MSOS404A-03C

Modification Recommended Service Note

MSOS404A - MSO Infiniium S Series 4GHz 4 channel

The Problem - Under certain circumstances a PLL2 error may occur on the S-series products.

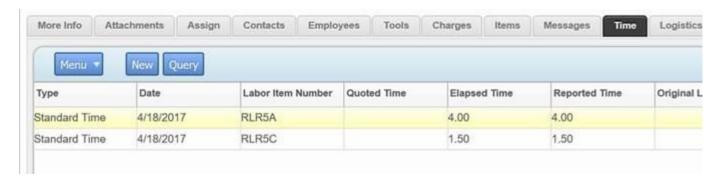
On older acquisition boards a PLL2 error message sometimes occurs. The error message appears on the screen as below:

There are new acquisition boards that fix this issue for the S-series scopes.

Please, use the 54911-69511 board until is gone. If you have a 54911-69511, then skip steps 1 and 2 and proceed to step 3. If there are no 54911-69511, then start with step 1 below.

- 1. If the customer needs to have software revision < 6.10.01001, then replace the acquisition board with the 54911-69532 board.
- 2. If the customer can have software revision >= 6.10.01001, then it can be replaced by any of these three boards: 54911-69521, 54911-69531, or 54911-69532.
- 3. Save the Serial Numbers of the replaced and the new Acquisition Boards in Siebel. Please, follow this procedure:
 - a. For each Service Order in Siebel, there is a tab labeled Activities:
